AMENDMENT REPORT 2

Jindera Solar Farm

June 2020

Project Number: 17-323

Figure 1-1 Jindera Solar Farm Constraints Layout

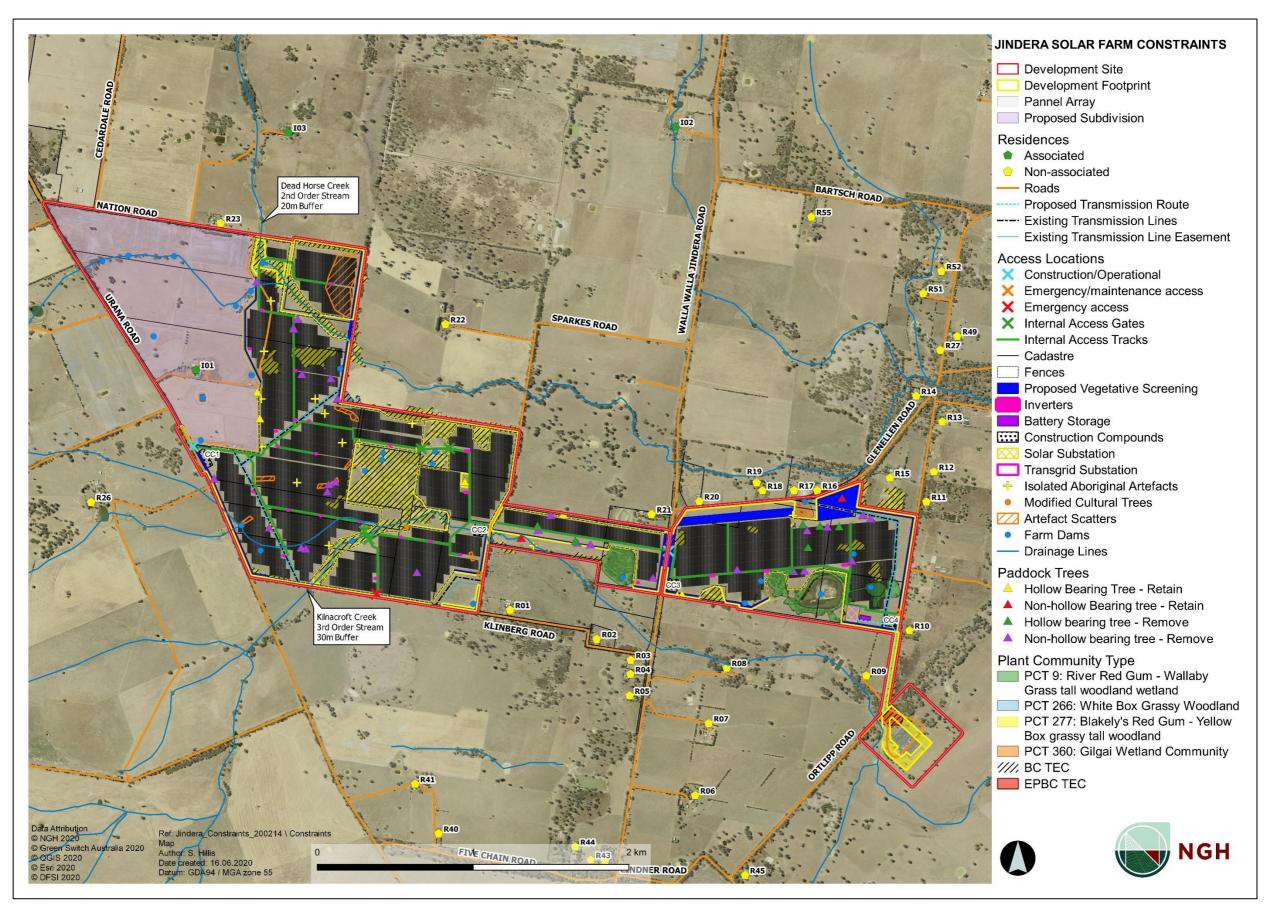
The proposed amended solar farm constraints layout map (Figure 1-1) illustrates the updated indicative layout, including a concept development footprint for the solar arrays, roads and fencing. Detailed design would allow for avoidance of sensitive features on site.

Figure 2-1 Retained native vegetation, and road and fence locations*

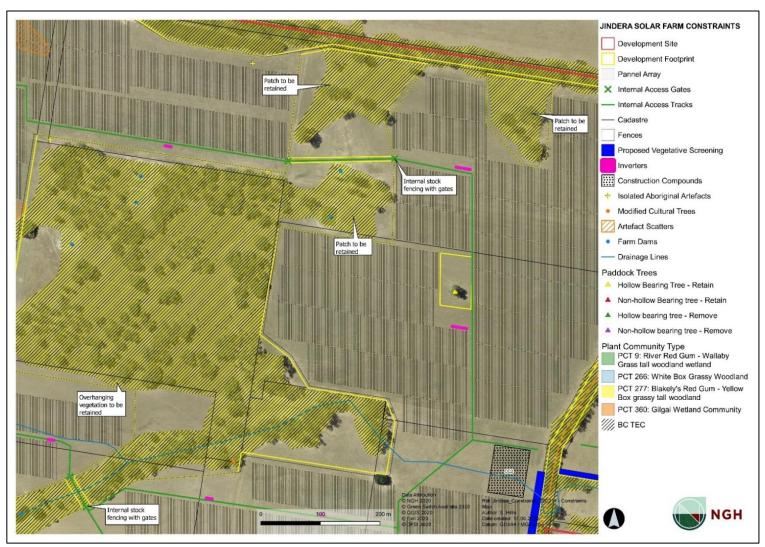
The development footprint has been refined to avoid three patches of PCT 277 within Lot 155 DP753342, as well as retaining additional vegetation overhanging Lot 138 PCT 753342 (Figure 2-1). This has resulted in a reduced clearing of approximately 3.9 ha of PCT 277 and overall reduction of credit offset obligations (Section 4.1).

The retained patches of PCT 277 (Figure 2-1) will be fenced by stock-proof fencing. Access gates will be added to allow access on the newly formed road that intersects two patches of vegetation. The length of Kilnacroft Creek will also be fenced with stock-proof fencing, with access gates to allow access on existing proposed internal roads.

Since the submission of the AIS and due to the updated stock-proof fencing around Kilnacroft Creek and the three areas of PCT (Figure 2-1), it has been determined that an additional 13.5 ha of development footprint will become unavailable for stock grazing. This represents an additional 4% decrease in stocking availability of the site.
